City of Franklin
May 27, 2025 10:00 AM City Hall

REQUEST FOR INFROMATION

Information Requested: Flooring Demolition

PROJECT: Franklin Apartments

References: Drawing and Pictures

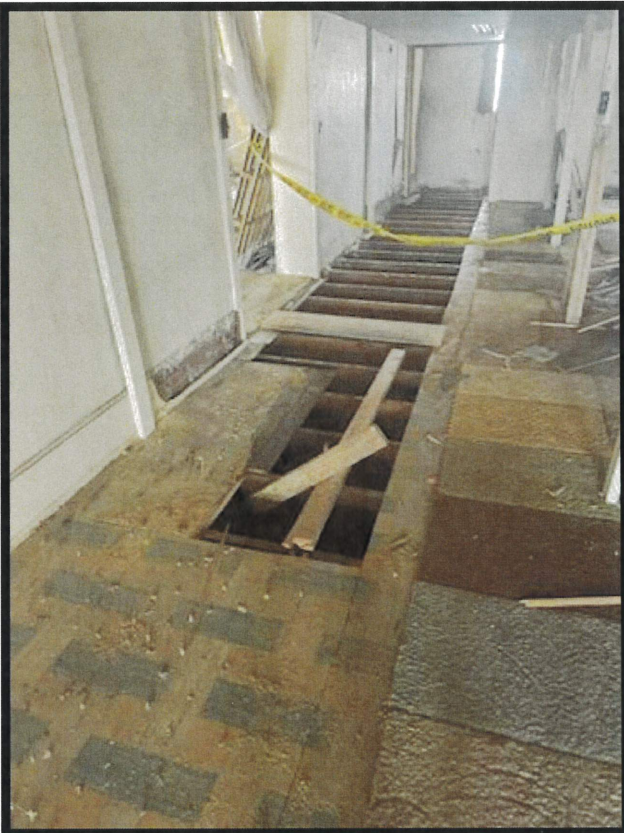
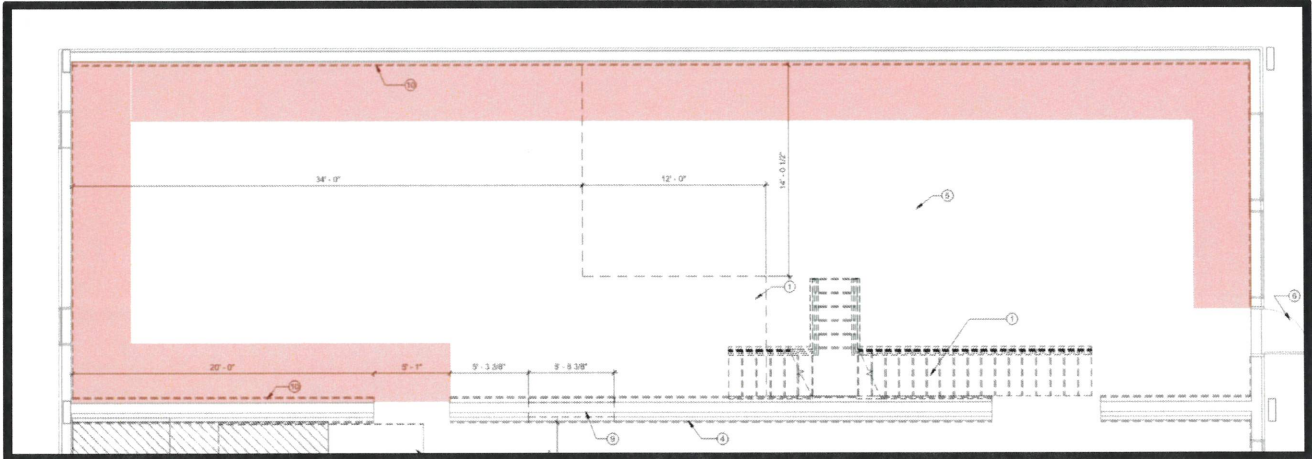
Midwest Plaster & Construction has proceeded with removing some of the existing floors in the north portion of the 1st floor. It is approximately 4' wide and to the extent depicted in the drawing and pictures.

Is Midwest Plaster & Construction replacing what they removed or how are we to proceed?

Please advise.
